Table 4. Credit Procedure: H-Dnet.com and Talon System Users

Table 5. Credit Procedure: GDP/SAP System Users

Figure 1. Install Steering Ballast

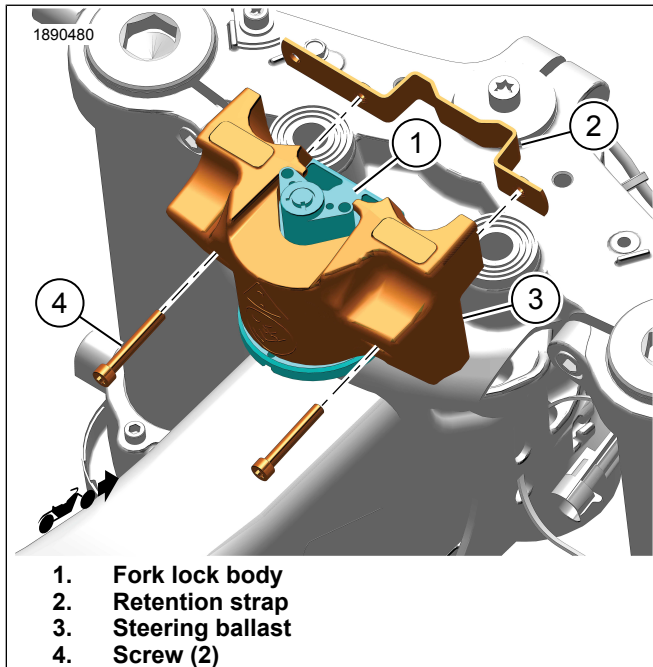
- See Figure 1. Install steering ballast (3) over fork lock body (1).
 - See Figure 2. Verify upper and lower retention features (1 and 3) are positioned properly.
- See Figure 1. Install retention strap (2) in front of fork lock body (1).
- Install screws (4). Tighten.
Torque: 35–42 **in-lbs** (4–4.8 N·m)
